Subject: Issuance of Amendment No. 79 to Facility Operating License NPF-6 -
Arkansas Nuclear One, Unit No. 2

The amendment revises the Technical Specifications pertaining to the Core Protection Calculators (CPC) as a part of the CPC Improvement Program.

Amendment No. 79
License No. NPF-6

ATTACHMENT TO LICENSE AMENDMENT NO. 79

Figure 3.2-1 Allowable Peak Linear Heat Rate vs Burnup
(COLSS out of service)

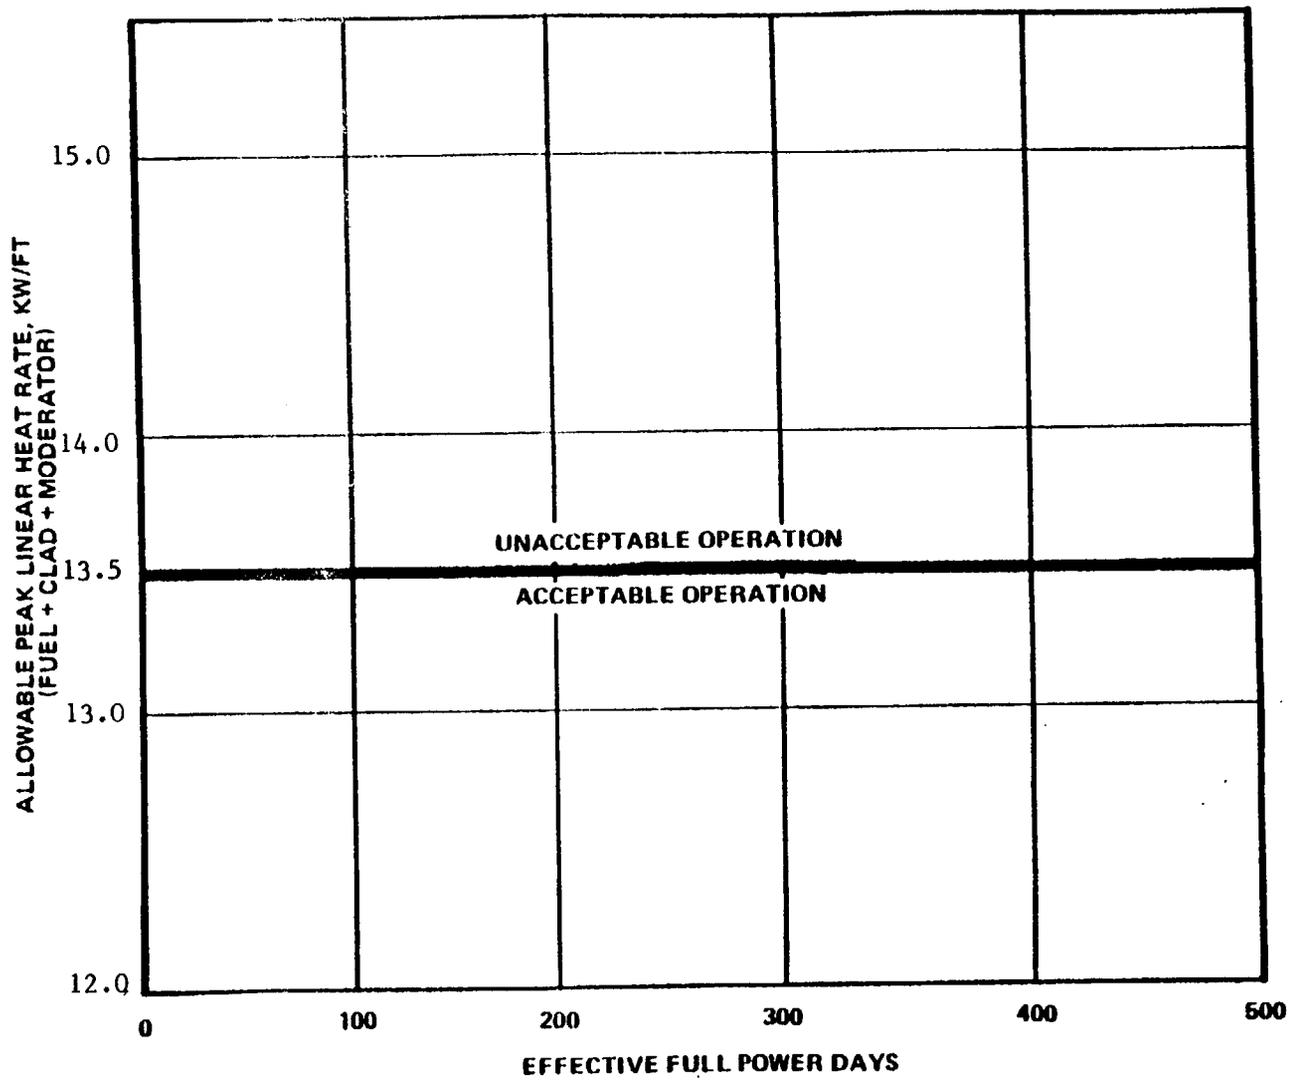
- a. Maintaining COLSS calculated core power less than or equal to COLSS calculated core power operating limit based on linear heat rate (when COLSS is in service); or
- b. Operating within the region of acceptable operation of Figure 3.2-1 using any operable CPC Channel (when COLSS is out of service).

The previous Limiting Condition for Operation (LCO) of Technical Specification 3.2.1, "Linear Heat Rate," has been replaced with two parts, 3.2.1.a and 3.2.1.b. Specification 3.2.1.a is applicable when COLSS (Core Operating Limits Supervisory System) is in service and requires the COLSS calculated core power to be maintained less than or equal to the COLSS calculated Power Operating Limit (POL) based on linear heat rate. These words replace the old Figure 3.2-1 and state the same requirement. The change is, therefore, acceptable. Specification 3.2.1.b is applicable when COLSS is out of service and requires operation within the allowable region of the new Figure 3.2-1 using any operable CPC channel. The old Figure 3.2-1 has been deleted and replaced with the words of Specification 3.2.1.a which state the same requirements. The new Figure 3.2-1 is similar to the previous Figure 3.2-2 and gives the allowable peak linear heat rate as a function of burnup when COLSS is out of service. The linear heat rate limit value in this figure has been lowered from 14.5 kw/ft to 13.5 kw/ft in order to bound future cycles. Since this lower limit is more restrictive and in a conservative direction, the change is acceptable.

FIGURE 3.2-2

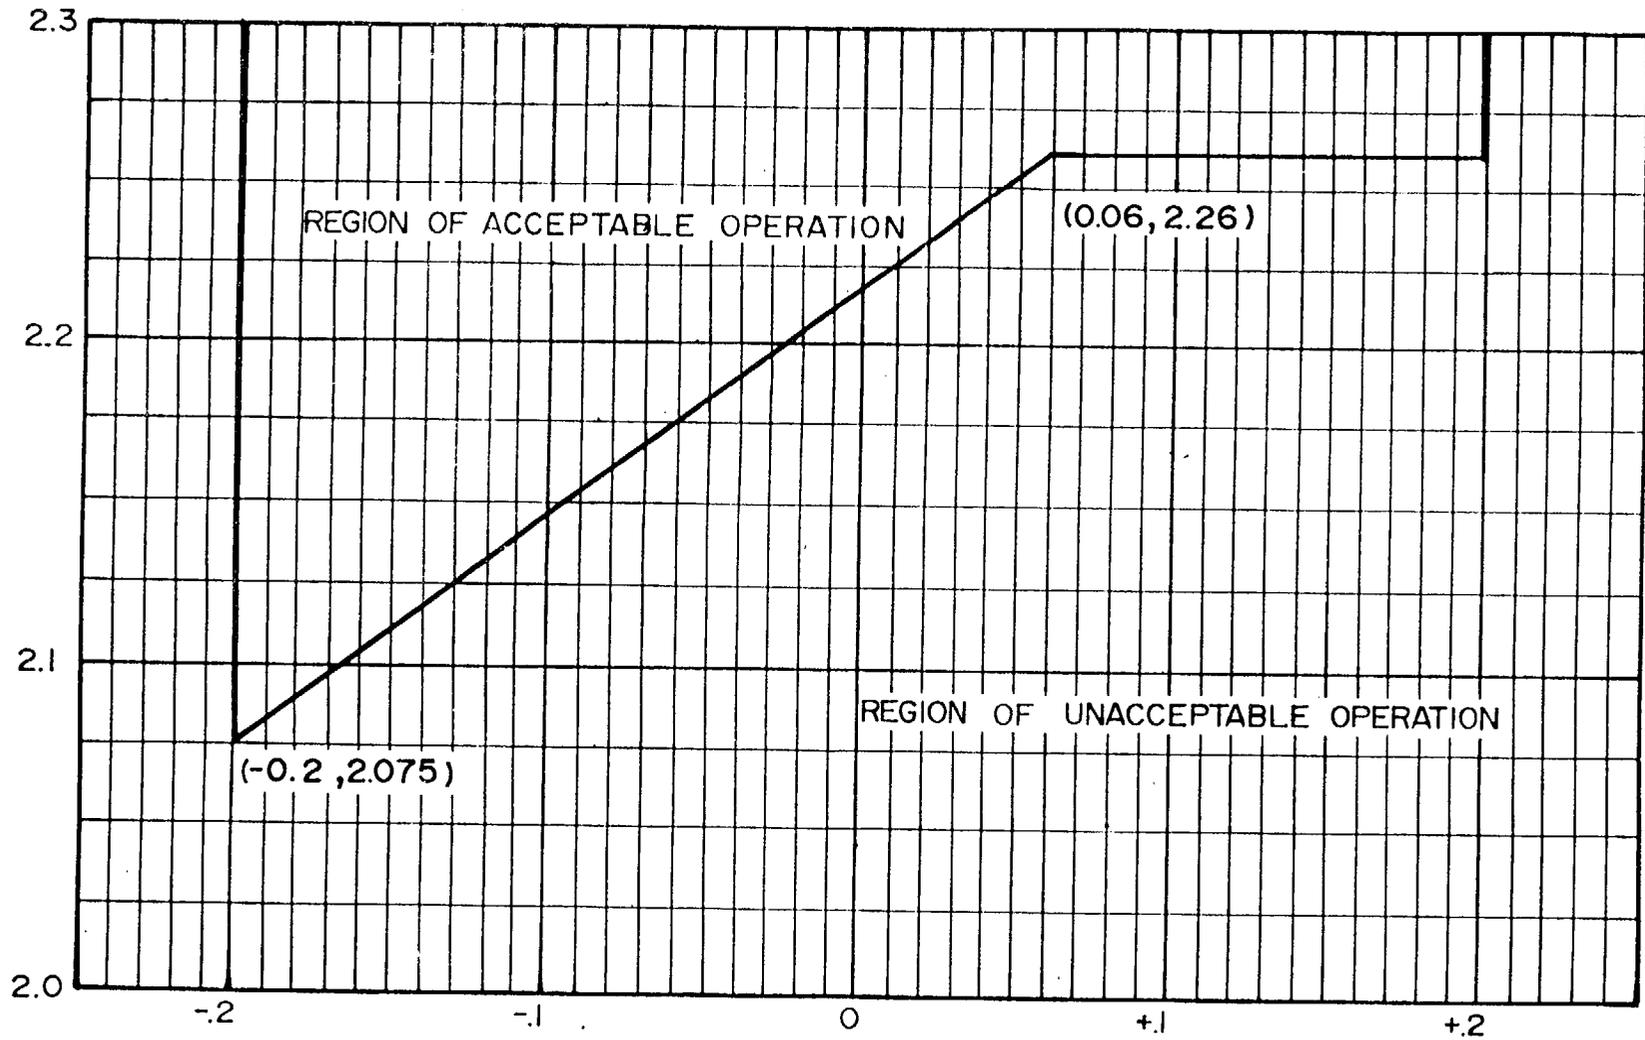
Parameters required to maintain the margin to DNB and total core power are also monitored by the CPCs. Therefore, in the event that the COLSS is not being used, operation within the limits of Figure 3.2-2 for CEAC operable or Figure 3.2-3 for both CEACs inoperable can be maintained by utilizing a predetermined DNBR as a function of AXIAL SHAPE INDEX and by monitoring the CPC trip channels. The above listed uncertainty and penalty factors are also included in the CPC.

The previous LCO of Technical Specification 3.2.4, "DNBR Margin," has been replaced with four parts, a, b, c, and d. Specification 3.2.4.a is applicable when COLSS is in service and at least one Control Element Assembly Calculator (CEAC) is operable and requires the COLSS calculated core power to be maintained less than or equal to the COLSS calculated POL based on DNBR. This is consistent with the previous requirement except that Figure 3.2-3 has been deleted and replaced with words to the same effect. The change is acceptable. Specification 3.2.4.b is applicable when COLSS is in service and neither CEAC is operable and requires the COLSS calculated core power to be maintained less than or equal to the COLSS calculated POL based on DNBR decreased by a penalty factor of 13% of rated power.

FIGURE 3.3-1

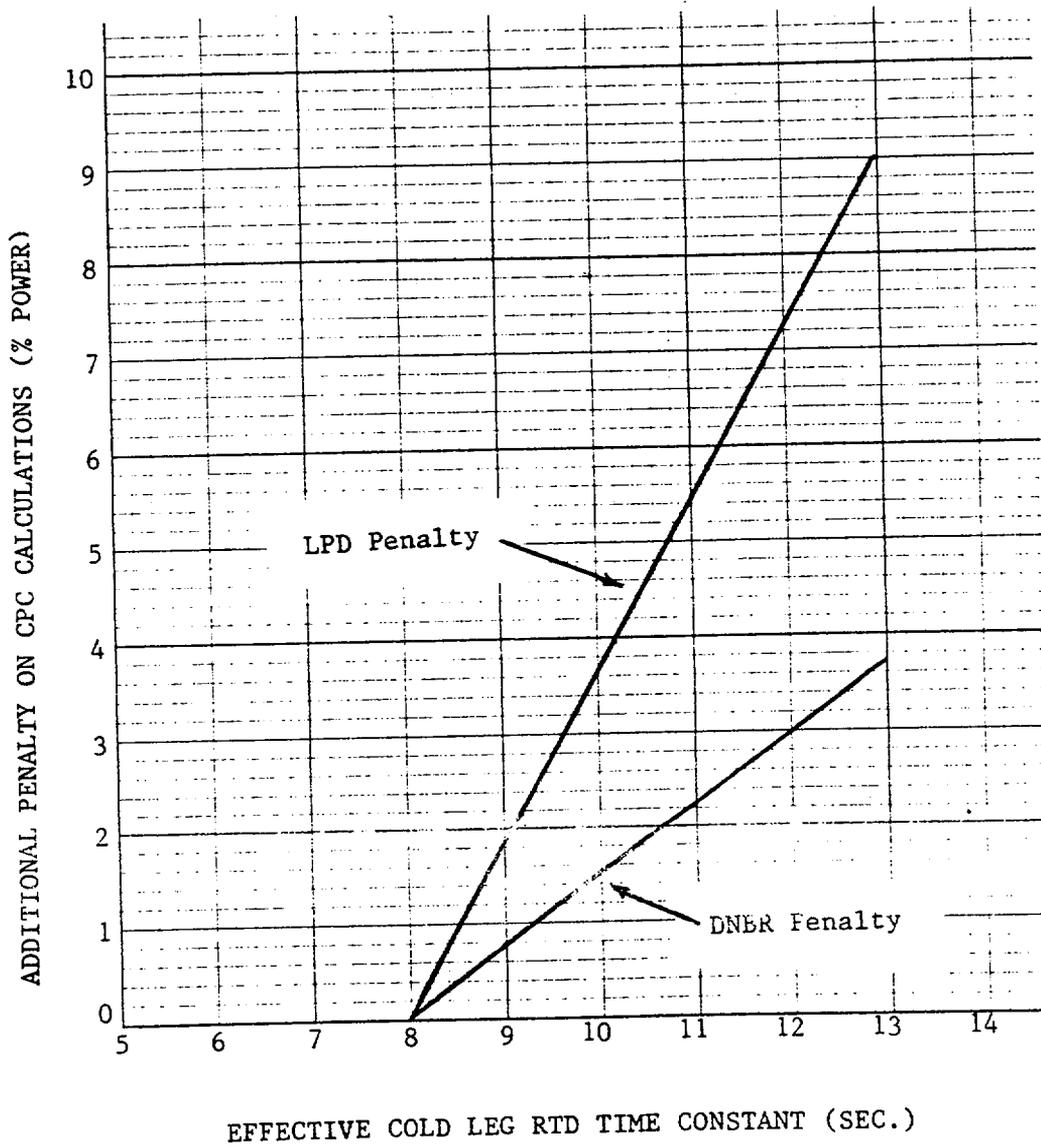
##Based on an effective resistance temperature detector (RTD) response time of ≤ 8.0 seconds. If the effective RTD time constant for a CPC channel exceeds 8.0 seconds, the DNBR and LPD penalties for the affected channel(s) shall be increased by the amount indicated on Figure 3.3-1.

The resistance temperature detector (RTD) response time of 6 seconds for a CPC channel, shown in the footnote to Table 3.3-2 of Technical Specification 3.3.1, has been revised. The CPC Improvement Program and related accident analyses now assume effective response times of 8 seconds for the RCS cold leg temperature RTDs and 13 seconds for the RCS hot leg temperature RTDs. The footnotes to Table 3.3-2 are revised accordingly. Figure 3.3-1 is also revised to give the DNBR and linear heat rate penalties to be applied if the effective cold leg RTD response time falls between 8 seconds and 13 seconds. Table 3.3-3 is deleted since the analyses now assumes response times up to 13 seconds and adjustments are no longer required for RTD response times less than this. These changes are acceptable.
